Page 1: DRC Site Plan - Applicant Information Sheet

# 100 LAS OLAS

# **DEVELOPMENT REVIEW COMMITTEE (DRC) COMMENT REPORT**

**Request:** Site Plan Level II Review: 120 Multi-Family Units  
and 228 Hotel Rooms

**Wave Streetcar Comments:**

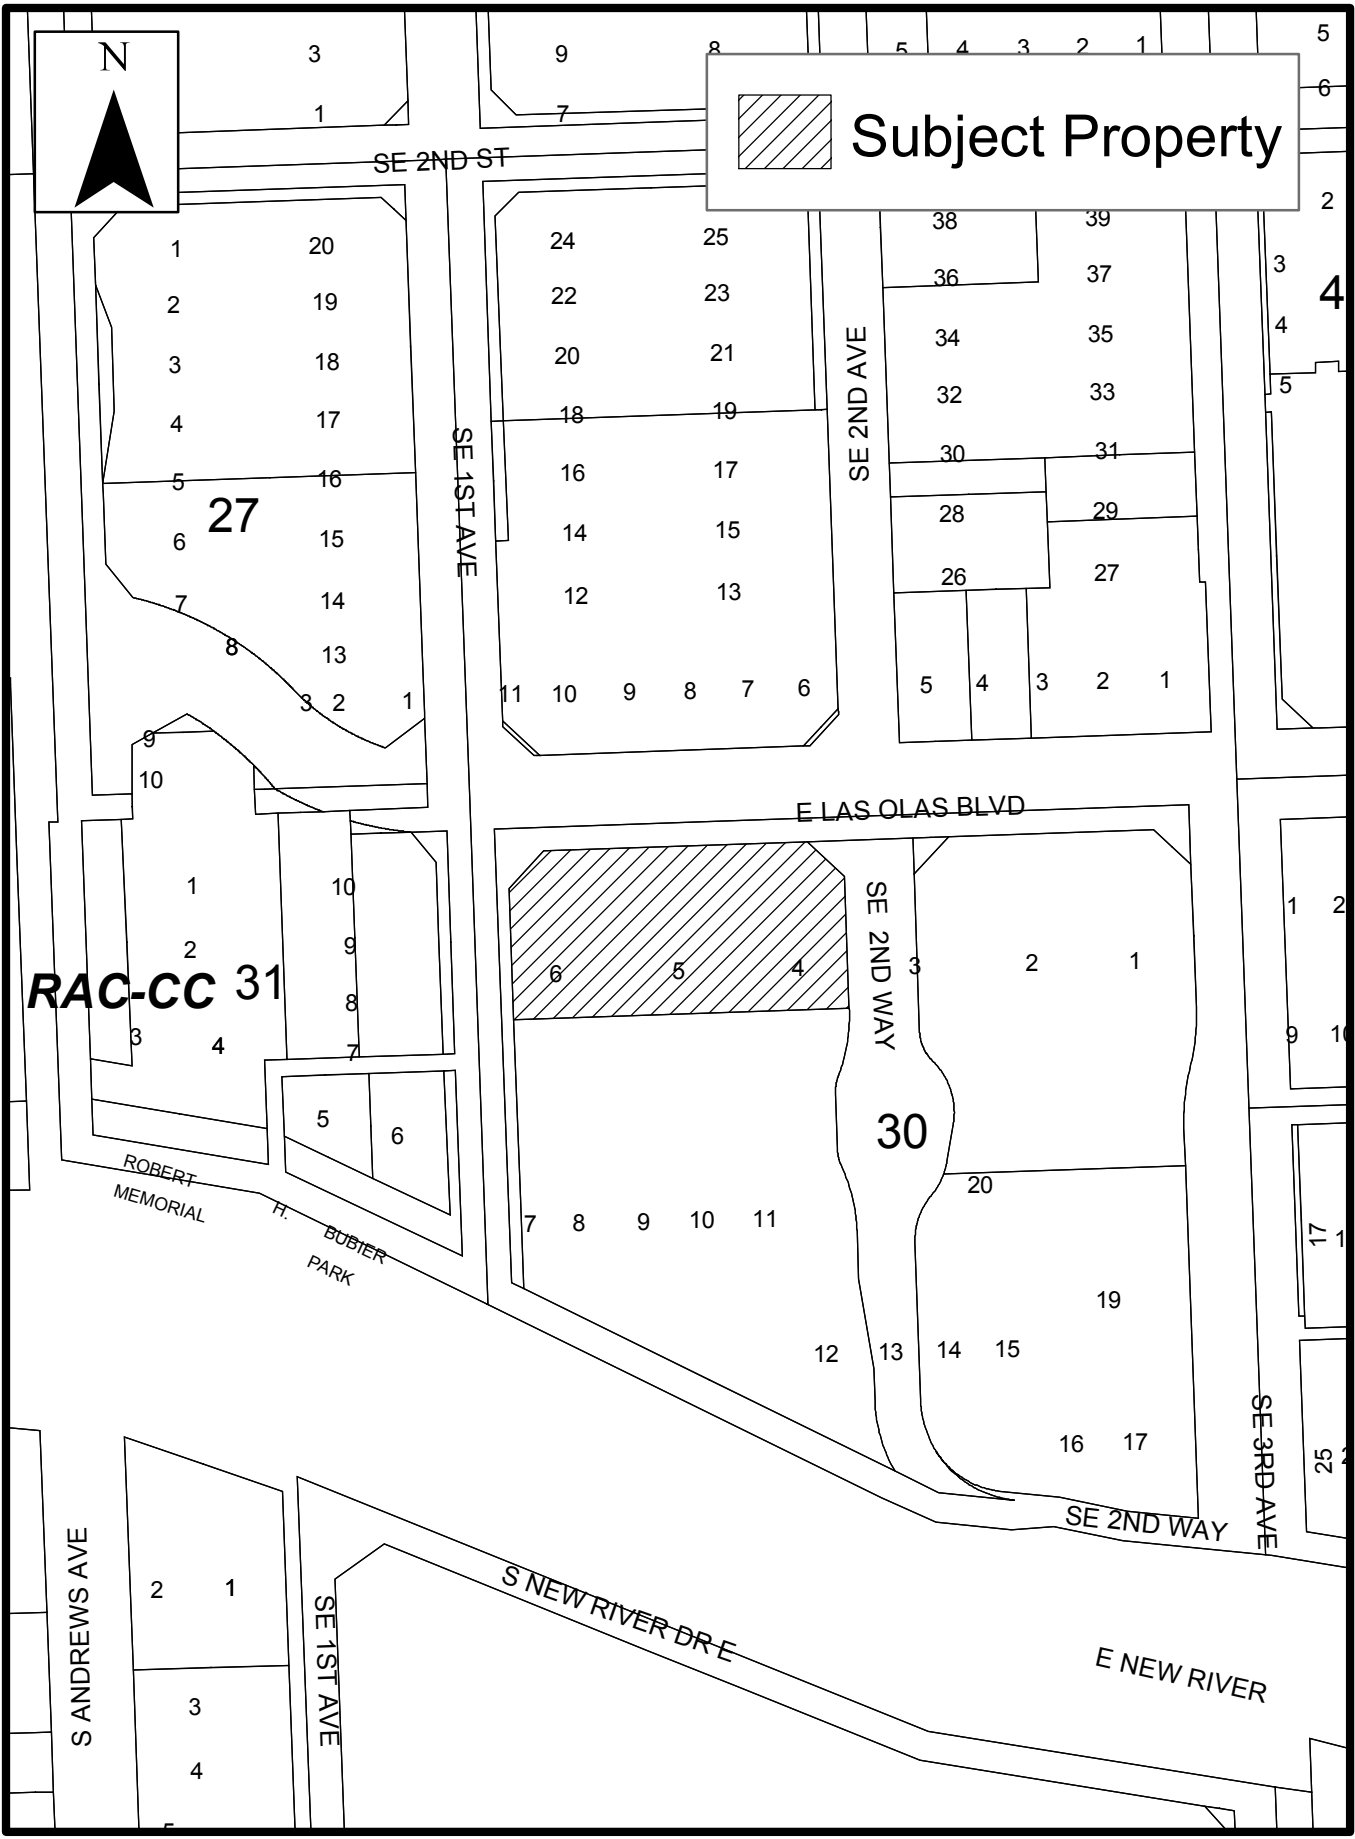
20. Please coordinate with the Transportation and Mobility and Landscaping Departments in order to determine the appropriate placement and species of trees and plantings along E Las Olas Blvd. Current plans are in direct conflict with the Wave Streetcar Project's Overhead Catenary System (OCS) plans.
21. Please coordinate with Elizabeth Van Zandt [Evanzandt@fortlauderdale.gov](mailto:Evanzandt@fortlauderdale.gov) in the Transportation and Mobility Department for the possible inclusion of decorative OCS poles along the Wave route in this location.
22. Please coordinate with Transportation and Mobility and Engineering Departments; regarding utility conflicts and relocations in connection with the Wave Streetcar Project.
23. Please coordinate with Transportation and Mobility and Engineering Departments; regarding roadway/curb grade changes in connection with the Wave Streetcar Project.
